IN THE UNITED STATES PATENT AND TRADEMARK OFFICE

SERIAL NO.: 09/685,412

FOR: GPS POSITIONING METHOD AND GPS RECEPTION APPARATUS

LETTER SUBMITTING REPLACEMENT DRAWING SHEET(S)

FIG. 13E

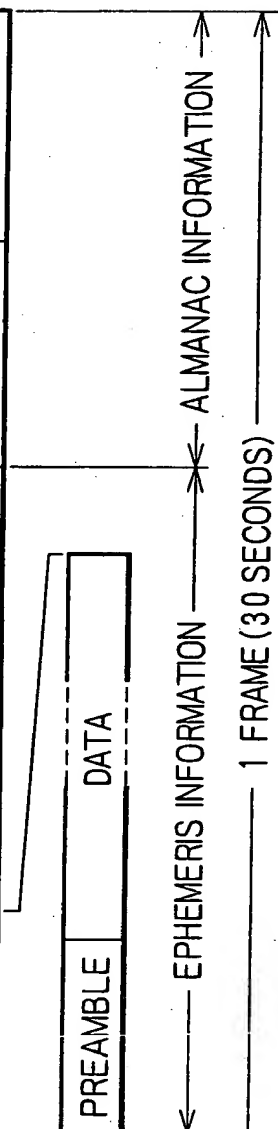
The attached sheet of drawings includes changes to Figures 13A, 13B, 13C, 13D, 13E, and 14. These sheets, which include Figures 13A, 13B, 13C, 13D, 13E, and 14, replace the original sheet including Figures 13A, 13B, 13C, 13D, 13E, and 14.

Including "Prior Art" to figures 13A-13E and 14 as required by the Examiner.
